Metro North-West JDAP Development Assessment Panel Agenda

Meeting Date and Time: 25 June 2018; 9:00am
Meeting Number: MNWJDAP/216
Meeting Venue: Department of Planning, Lands and Heritage
140 William Street, Perth

8.1 Property Location: Lots 348 and 347 (50 and 52) Littorina Avenue, Heathridge
Development Description: Construction of fourteen (14) multiple dwellings
Applicant: Mr Carlo Famiano (CF Town Planning & Development)
Owner: Mr Harley William Francis Burke
Responsible Authority: City of Joondalup
DAP File No: DAP/18/01377

8.2b Property Location: Lot 100 (304) Scarborough Beach Road, Osborne Park
Development Description: Motor Vehicle Sales and Repair
Applicant: Mr Nik Hidding (Peter Webb & Associates)
Owner: Mechanical Holdings Pty Ltd & Ryder Pty Ltd
Responsible Authority: Western Australian Planning Commission
DAP File No: DAP/17/01353

SITE / LAYOUT PLAN
1:200

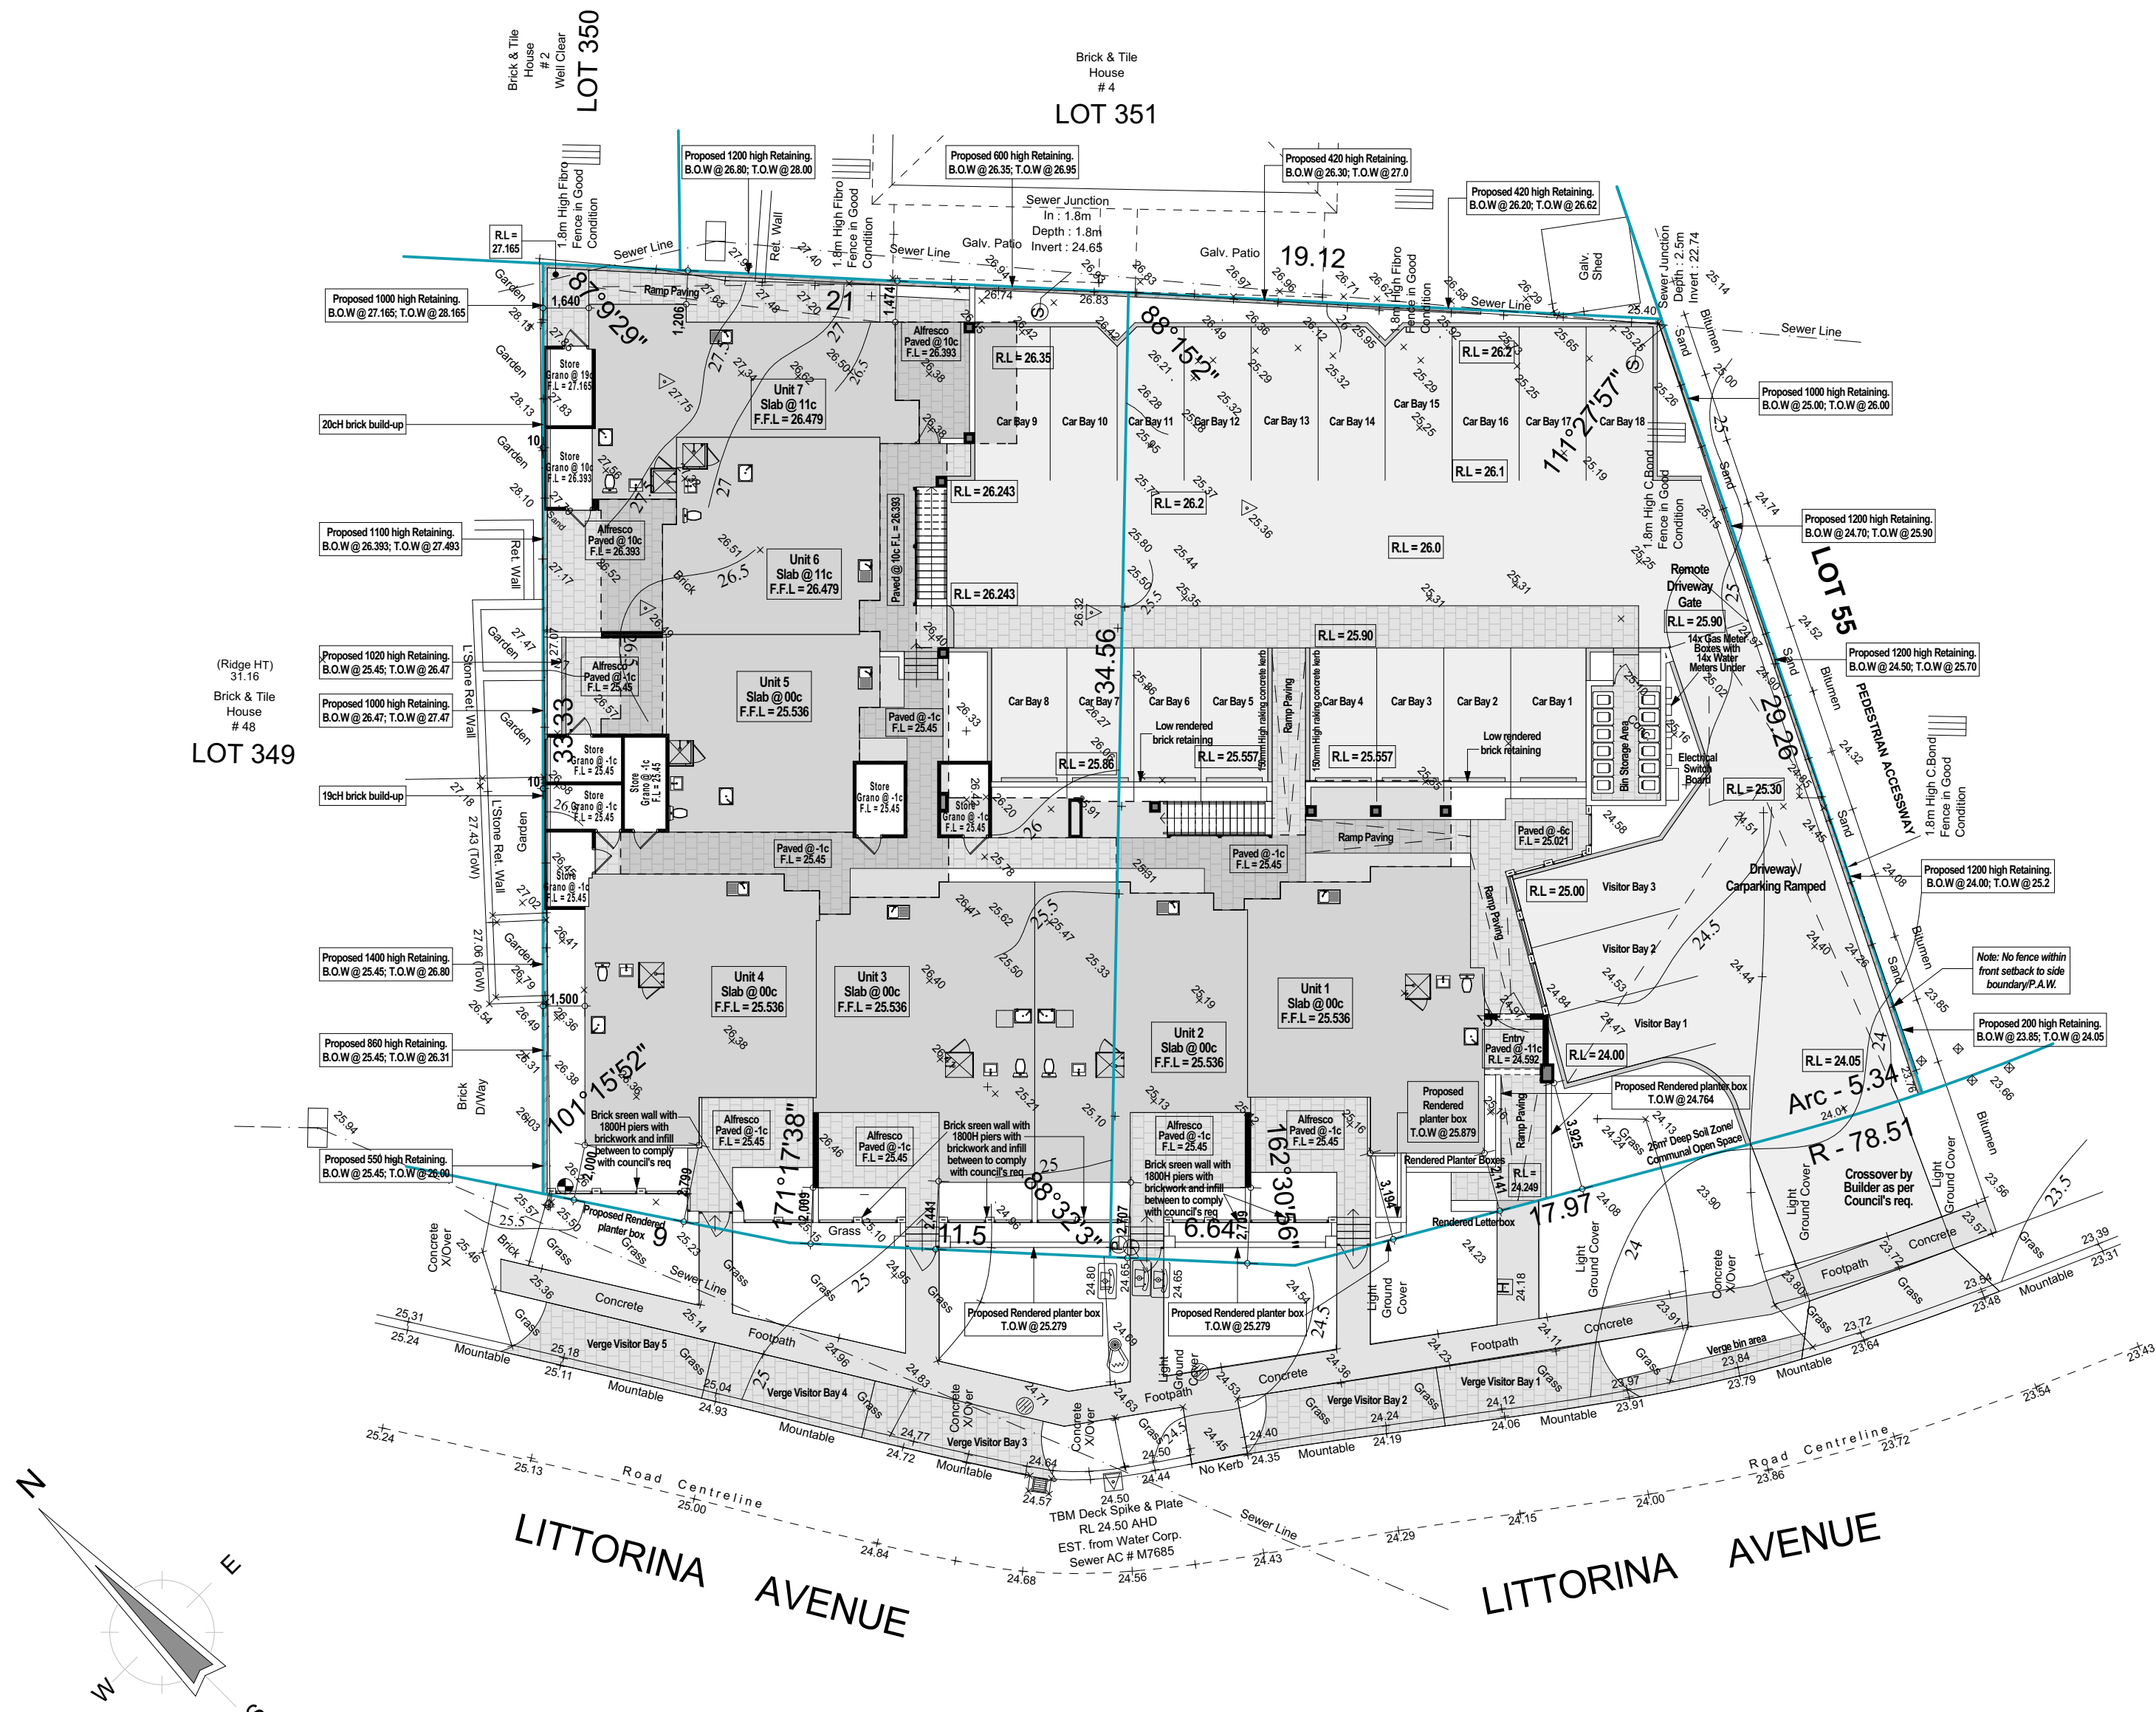
Lot boundary walls	A wall may be built up to the lot boundary, where it abuts an existing or simultaneously constructed wall of equal or greater	Cumulative north - western boundary wall length (stores) of 12.3m in lieu of a maximum of 9.77m.	2.53 metres longer than the deemed-to-comply requirement. See officer comment below.

Design of car parking spaces	<p>Car parking spaces and manoeuvring areas designed and provided in accordance with AS2890.1 (as amended) (clause 6.3.4 of the R-Codes).</p>	<p>The three proposed on-site visitor bays located at the front of the development appear to have an average grade across the width of the spaces of around 13.2%.</p>	<p>The on-site visitor bays do not comply with AS2890.1.</p> <p>See officer comment below.</p>

There is a proposed level difference of up to 1.5 metres between the subject site and the adjoining property to the north-west of the lot, with the subject lot being on the lower side. Notwithstanding the additional boundary wall length proposed, as demonstrated on the development plans and elevations (Attachment 2), the provision of a standard 1.8 metre high dividing fence on the higher (neighbouring) side of the boundary will adequately screen the boundary walls for the proposed length. As such, the cumulative lot boundary wall length is considered to be acceptable, as the visual impacts of the walls are adequately moderated and considered to meet the relevant design principle of the R-Codes.

In accordance with clause 6.3.3 of the R-Codes, a ratio of 0.25 visitor bays for each dwelling is required on-site, meaning a total of 3.4 (4) visitor bays are required on-site to meet the R-Code requirements. The City's *Residential Development Local Planning Policy* (RDLPP) requires a greater number of visitor parking bays be provided at a rate of 0.5 visitor bays per dwelling and provides that such parking can be provided in the adjacent verge. Under the City's policy, a total of seven visitor car parking bays are required for the proposed development. A total of eight visitor bays are proposed, three of which are proposed on site and five which are proposed within the Littorina Avenue verge.

In relation to the deemed-to-comply requirement of R-Code clause 6.3.6 Site works C6.1, the development proposes a maximum of 0.697 metres of fill between the street and the building in association with the unit 1 planter in lieu of a maximum amount of fill of 0.5 metre.

SITE / LAYOUT PLAN
1:200

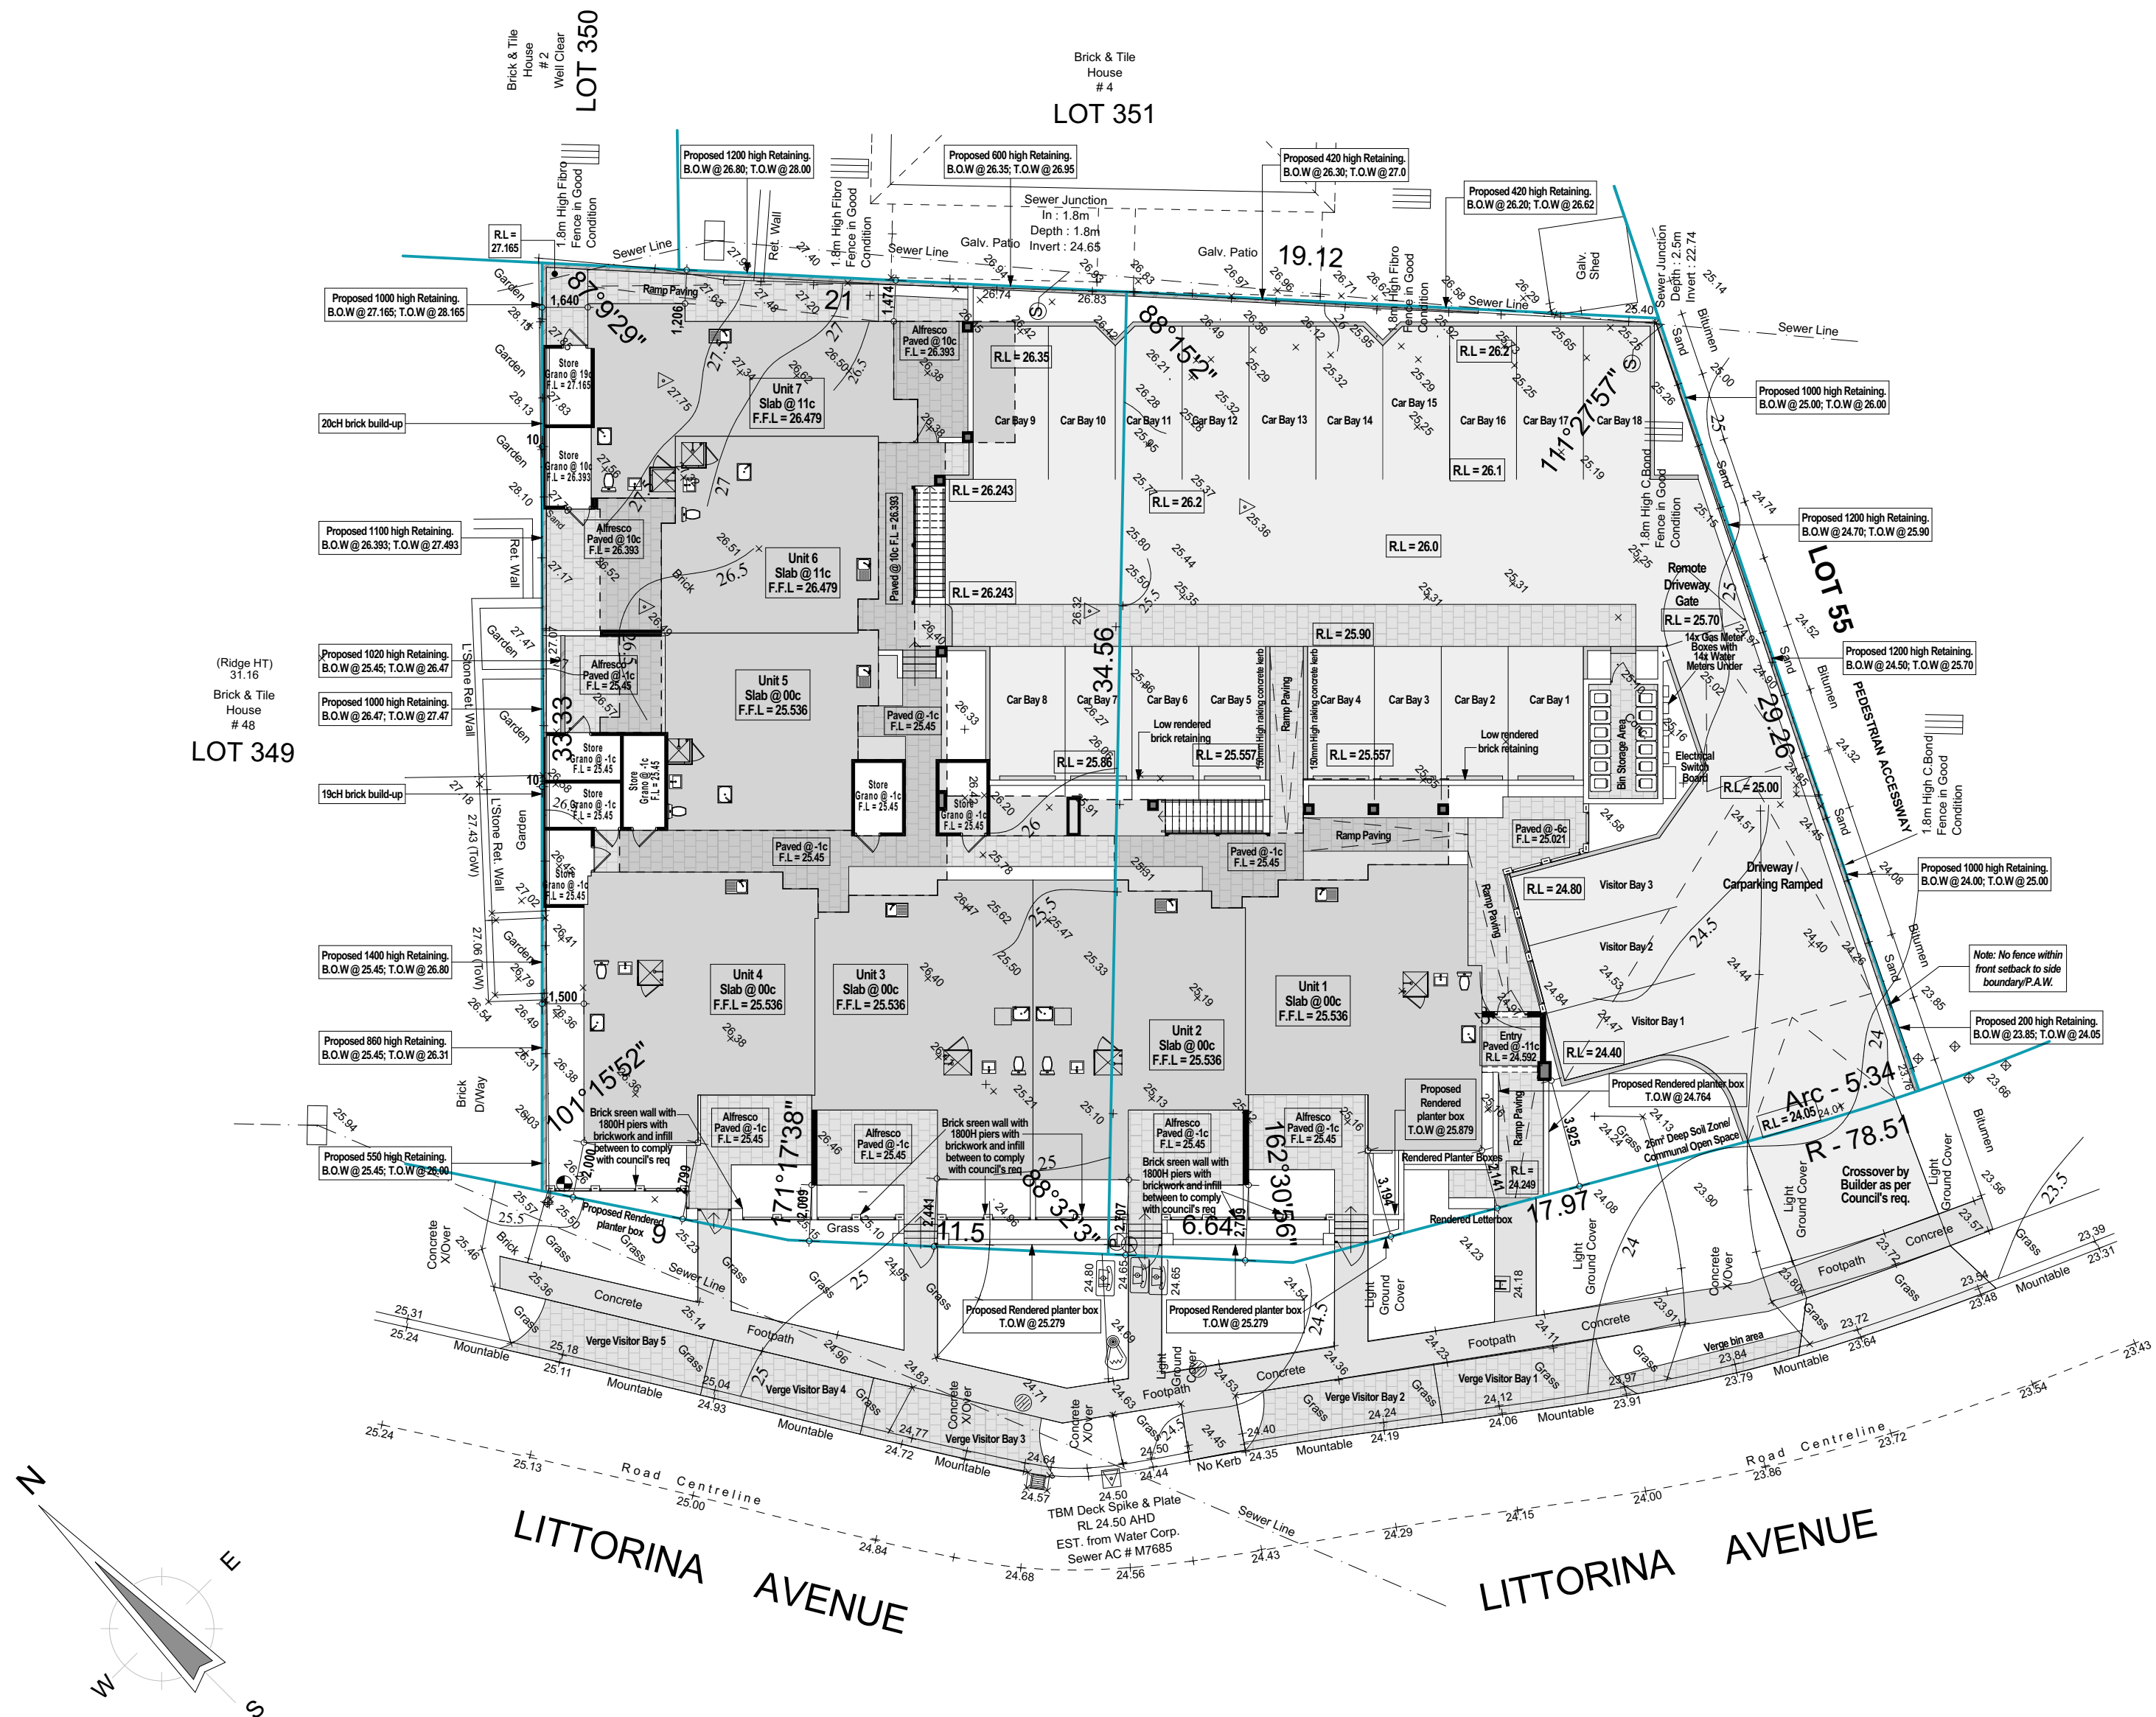
The amended plans include an alteration to the gradient of the three on-site visitor parking bays located south east of, and adjacent to Unit 1. The proposed amendment to the parking bay gradient seeks to specifically address refusal reasons 2, 3.1 and 4.1 of the RAR submitted by the City of Joondalup. Notwithstanding the amendments proposed, the City's recommendation for refusal of the development stands given the balance of refusal reasons remain outstanding. It is also noted that even if the amendments to address grades are such that the three visitor bays are acceptable, a visitor parking shortfall would still remain to a degree which the City considers unacceptable. A copy of the amended plans for consideration in place of Attachment 2 referred to in the City's RAR is attached.
